Beachlands Wastewater Treatment Plant Discharge Consent – DIS60433803

The following sets out Watercare's response to the Section 92 requests received by email on 30th July in relation to the Beachlands Wastewater Treatment Plant discharge consent.

Watercare - Beachlands WWTP Discharge Consent Application – Response to Council s92 further information request

Figure 2: The nitrogen cycle.²

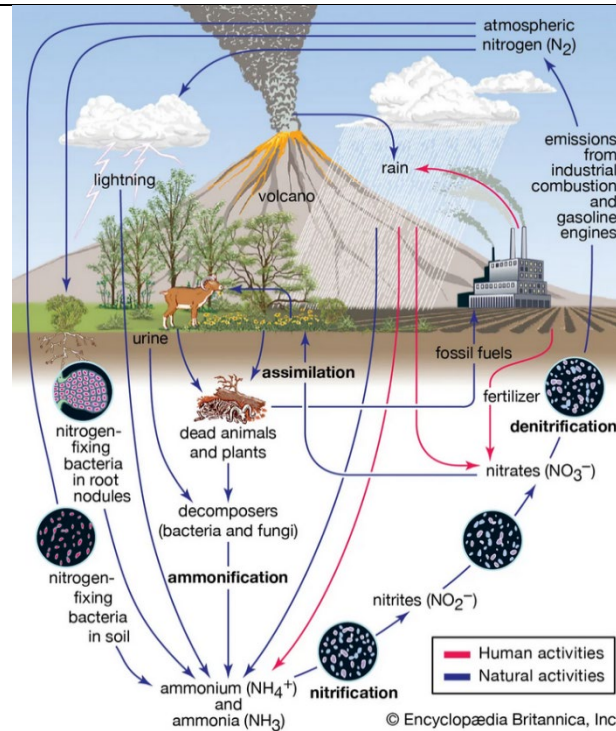
11.	The last bullet point on page 10 of the ecological report refers to TN, Amm-N and Nitrate-N concentrations are at Attribute Band B; and dissolved inorganic nitrogen (DIN) at levels expected to contribute to eutrophication (noting here that DIN is the sum of nitrite-nitrate-nitrogen (NNN), ammoniacal-nitrogen (Amm-N) and nitrate-nitrogen (Nitrate-N). Noting the current state assessment has been provided for PE 11,000, what are the expected concentrations (median, average, 95th percentile) and	This is related to Q1 and will be provided in the updated effects assessment report. Note: Table 16 has this for nitrate and DRP. Ammonia is not applicable, and we discussed this in the report.

Regarding point 2, ammoniacal-N has been measured at downstream receiving environments so no need to estimate it (see Figure 19 of report). We reiterate the above statement that only in the farm pond that concentrations of ammoniacal-N could be potentially toxic, with concentrations at site 15 (proposed mixing zone) in NPS-FM attribute band B.

Regarding point 3, the Beachlands WWTP currently produces effluent with a very low level of ammoniacal-N. Based on the overland performance investigation, the overland
